SERVICE LETTER

No. 878A

Piper Aircraft Corporation

Subject: Oil Breather Tube Inspection/Alignment

SKETCH "A"

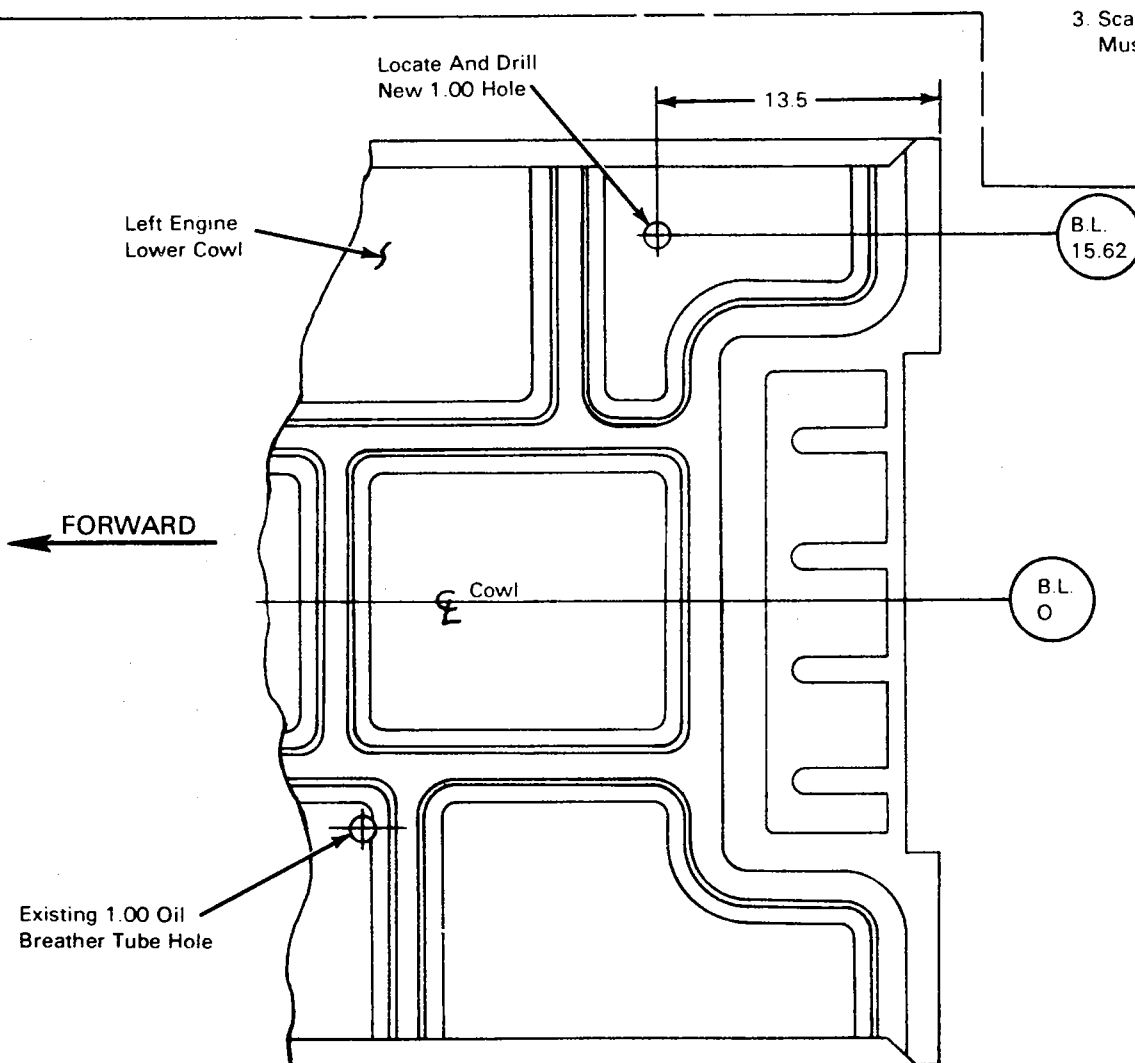
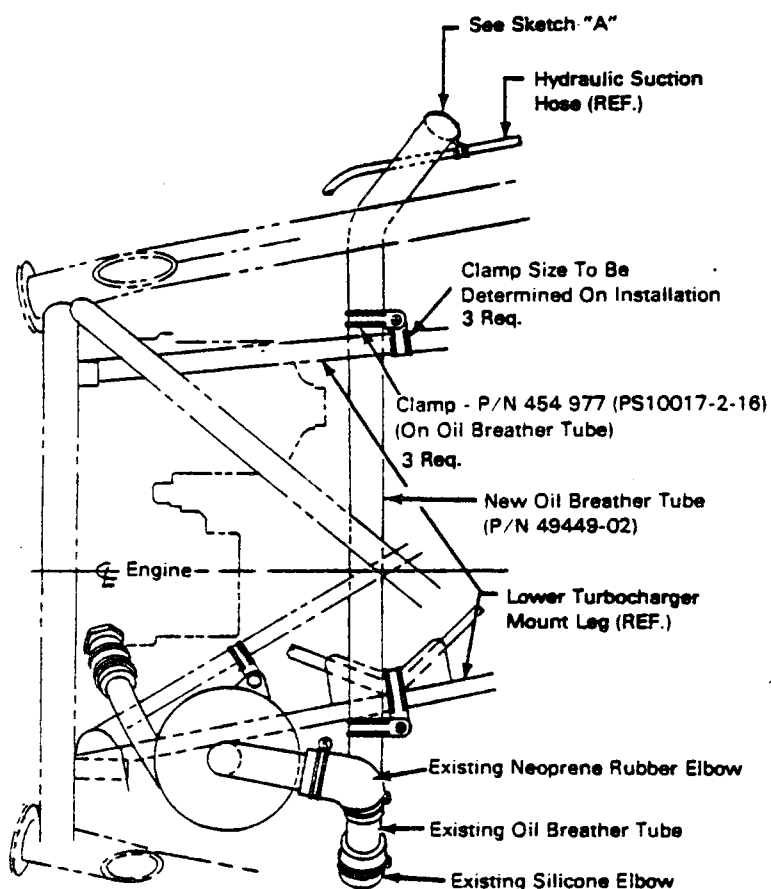
1. Gain access to the oil breather tubes.
2. Inspect the tubes for proper alignment, and realign if necessary. Refer to the "Oil Breather Tube Alignment Detail" on attached SKETCH A to insure proper positioning of tubes.

1. Remove the upper and lower cowl from the left engine.
2. Locate and drill a one inch hole thru the lower cowl as shown on Sketch "A". NOTE: It is permissible to leave the existing one inch oil breather hole in the lower cowl open. If desired, a patch plate (Piper part no. 481 096) may be installed to plug this existing hole.

5. Reinstall the lower cowl. Inspect the new oil breather tube for proper alignment with the new one inch hole in the lower cowl. Refer to Sketch "A" to insure proper positioning of oil breather tube.

1. Centerline Of Breather Tube Must Align With Centerline Of 1.00 Hole In Lower Cowl.
2. Breather Tube Must Not Extend Thru 1.00 Hole In Lower Cowl. Maximum Distance Between End Of Tube And Cowl Surface is .25.
3. Scarf On End Of Breather Tube Must Face Forward.

SKETCH "B"

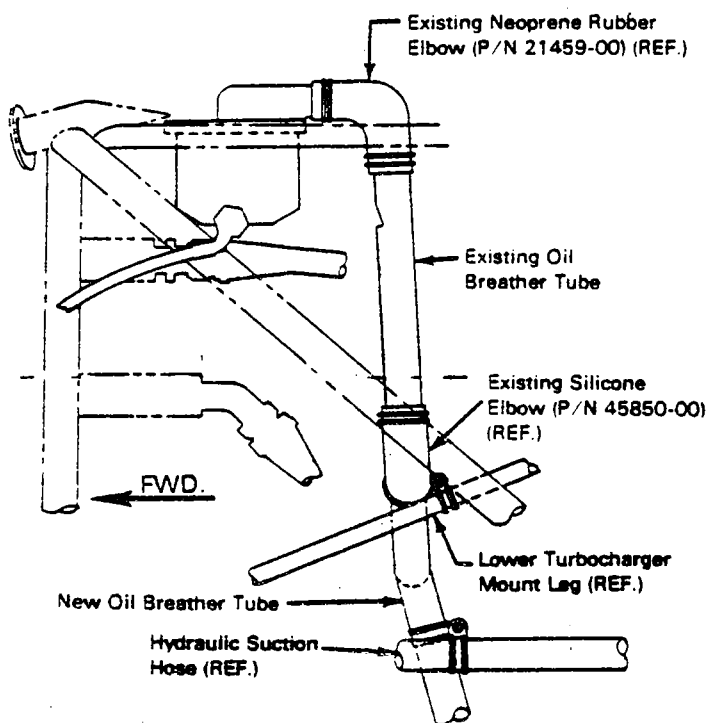
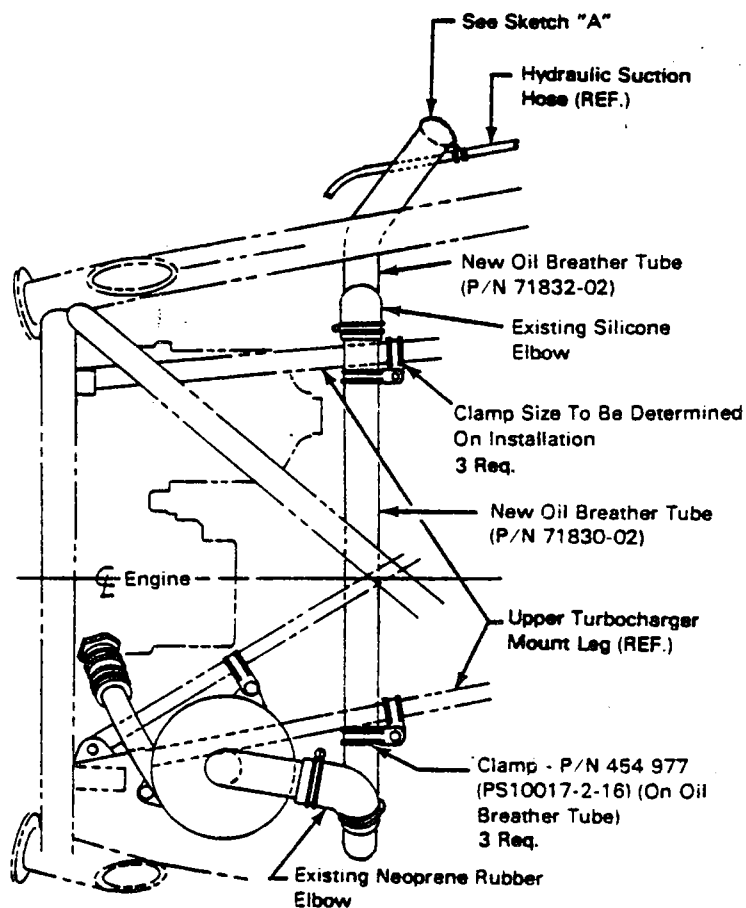
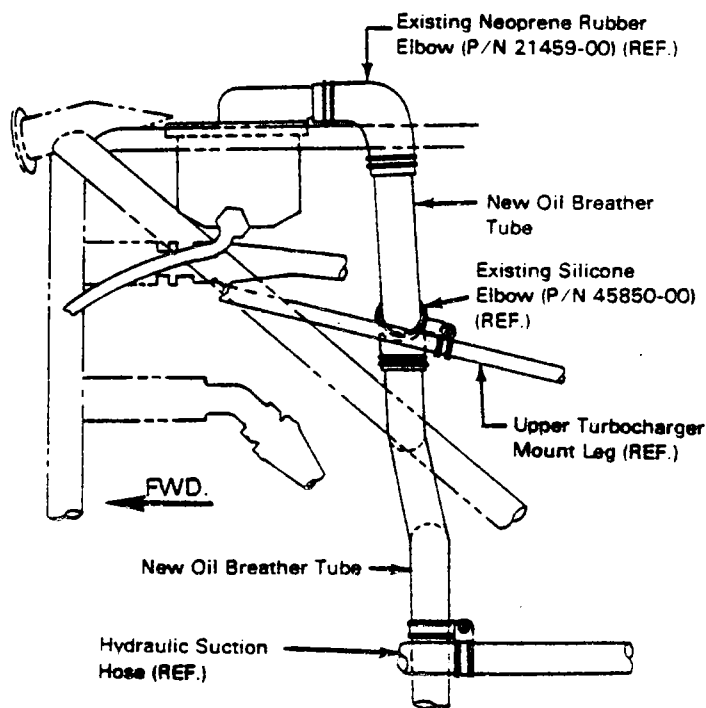
3. On PA-31-325 and PA-31-350 aircraft, remove the existing oil breather tube and install new oil breather tube (P/N 49449-02) as shown on Sketch "B". On PA-31 aircraft, remove the two (2) existing oil breather tubes and install new oil breather tubes (P/N 71830-02 and P/N 71832-02) as shown on Sketch "B". NOTE: If existing neoprene rubber and silicone elbows, as shown on Sketch "B", are deteriorated, replace with new parts.

4. Secure new oil breather tube(s) to existing structures for support and to prevent chafing and interference. Refer to Sketch "B" for recommended clamping configuration.
